# 11.6 Roseburn Park Walk and Cycle Improvements

## Consultation & Monitoring Summary Report

August 2018

**Figure 1 Photographs of Trial Improvements**

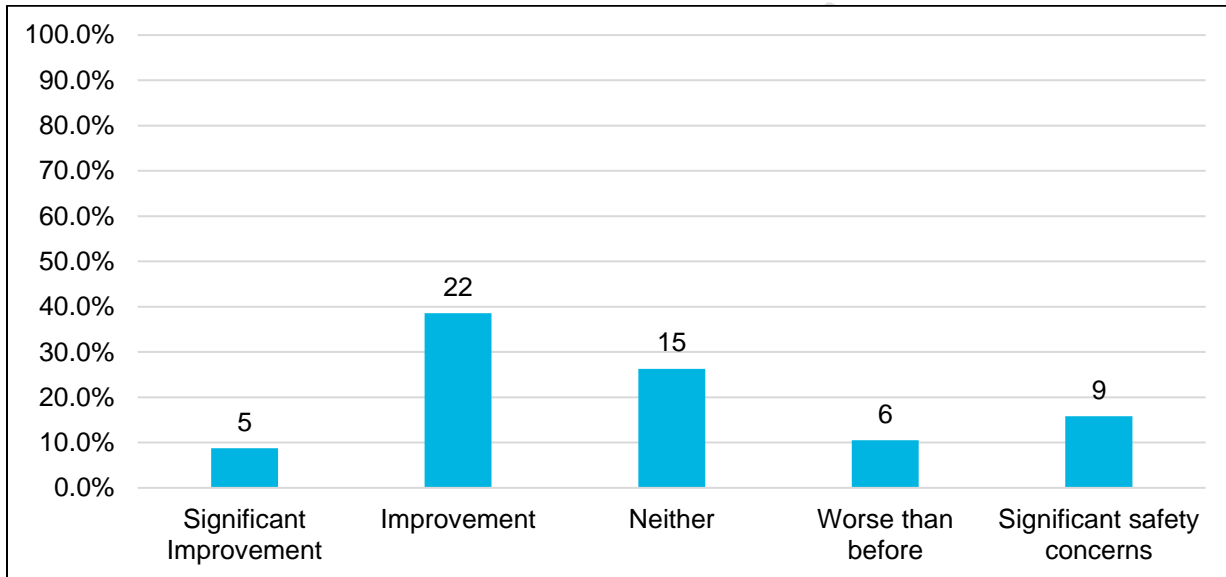
- Segregation of pedestrians and cyclists on the path through the park, on the eastern and western approaches to the junction of the paths; and
- Installing low level planters at the corner of the south-eastern building at the junction of the paths within the park, with the aim of directing people away from the blind corner, thereby reducing the potential for collisions.

- **Retain the white line segregation around the toilet block/east side of the junction.**
- **Remove the white line segregation around the pavilion/west side of the junction.**
- **New slow markings and signage to promote slower speeds on bikes and use of bells.**
- **Provide additional planters to the Friends of Roseburn Park for positioning along the 'Green' building block.**
- **Upgrades to the path surface where (1) ponding occurs and (2) the surface is in poor repair**
- **Improvement to the lighting**
- **Safety improvements to the junction where the park path crosses the access road to the ice rink. This will incorporate the re-alignment of bollards and ground markings to highlight the junction crossing to all users.**
